Reply to Referee #1 interactive comment

Figure 1: Systematic connection in the DA framework, and the association between the eight selected factors in the analysis.

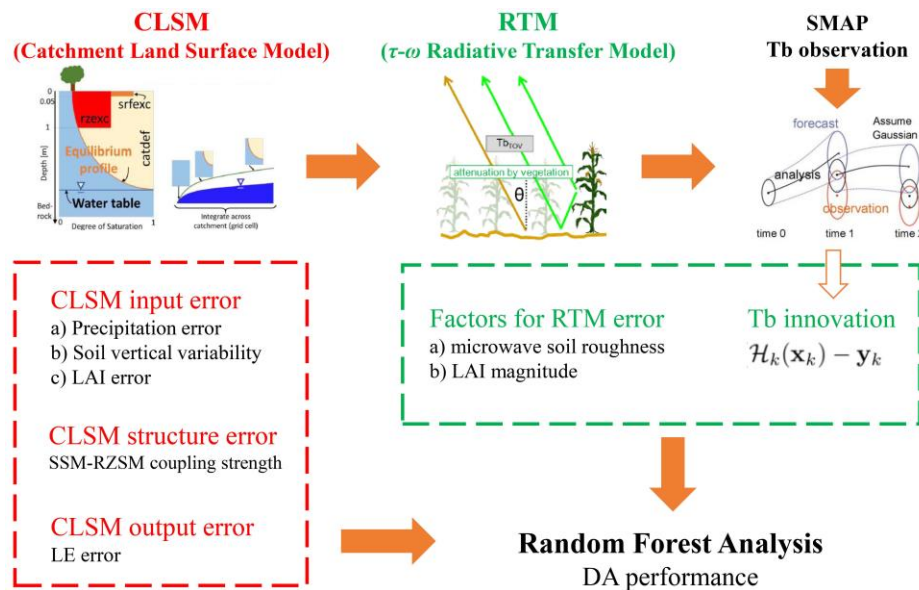
1. I think the descriptions of the reason of choosing these factors are not good/clear enough. It seems that the reason is because they are components of this DA system. Although it is true that there are many stuff in the DA system, please try to explain the reason in a more consistent/informative way.

We also added a figure (new Figure 1) that shows a schematic of the DA framework and the connections between the eight selected factors in the analysis.
